Subject: AP1000 COL Standard Technical Report Submittal of APP-GW-GLR-005, Revision 2 (TR-09)

APP-GW-GLR-005, Revision 2

TITLE: Containment Vessel Design Adjacent to Large Penetrations

5. DCD MARK UP

Figure 3.8.2-7

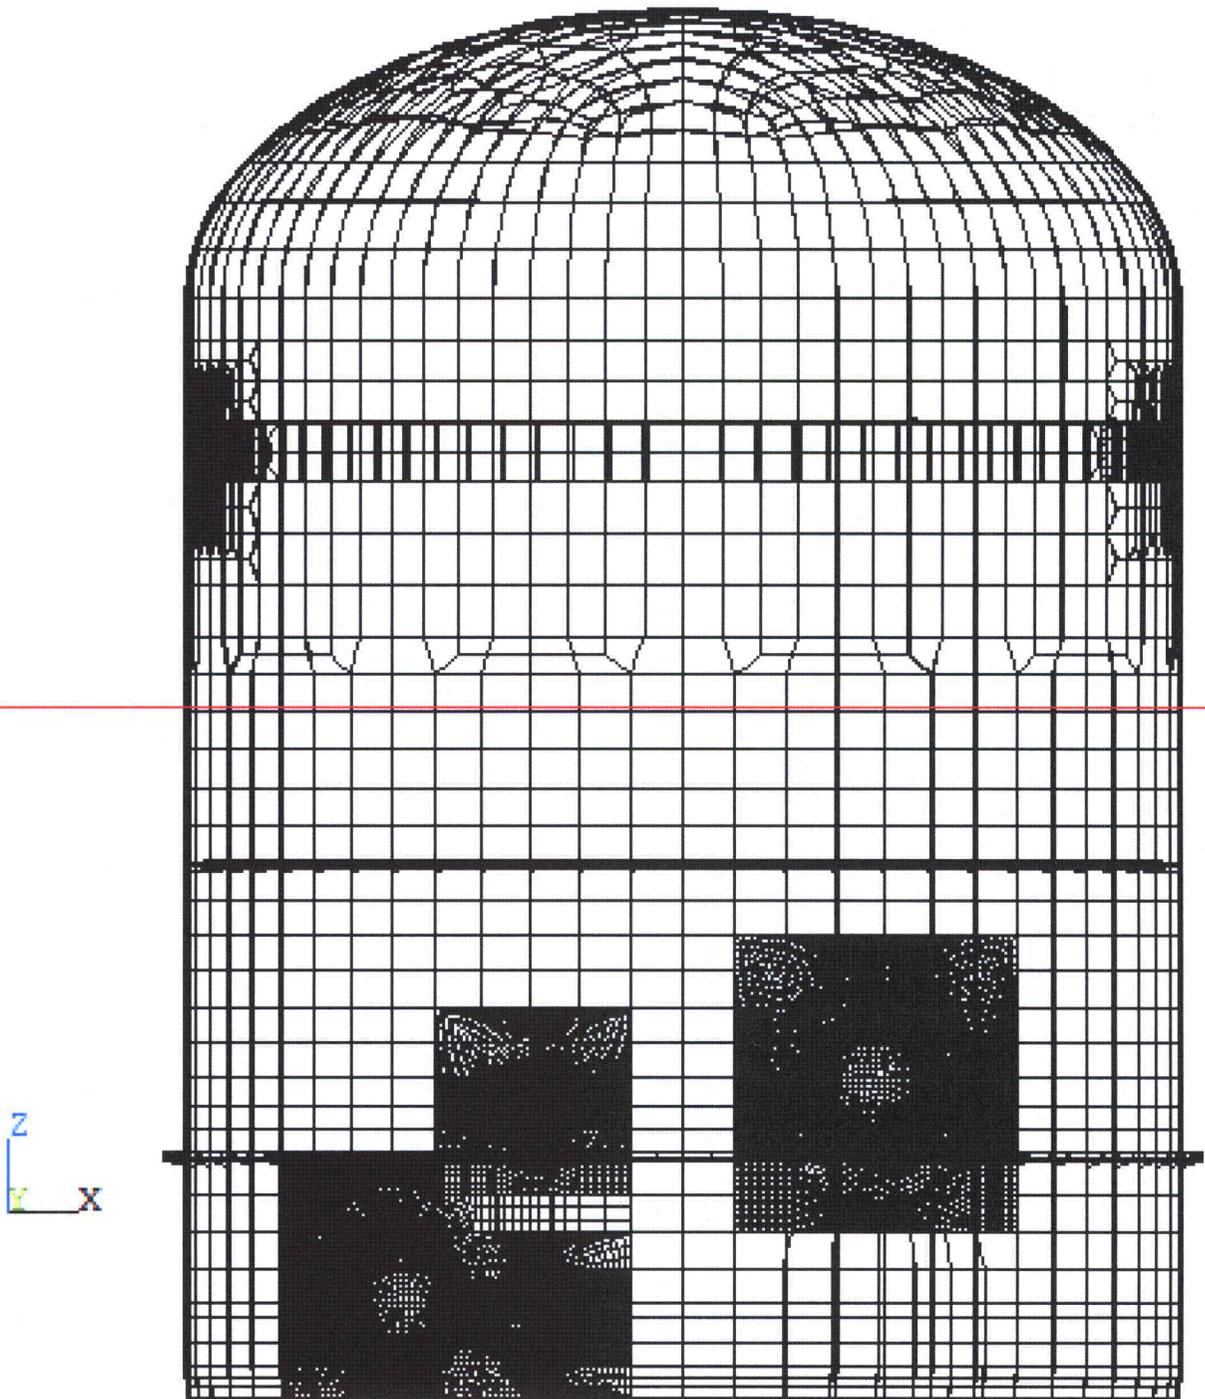
Replace Figure 3.8.2-7 by the figure below

Finite Element Model for Large Penetration Local Analyses 5.2 DCD Changes to Rev 16
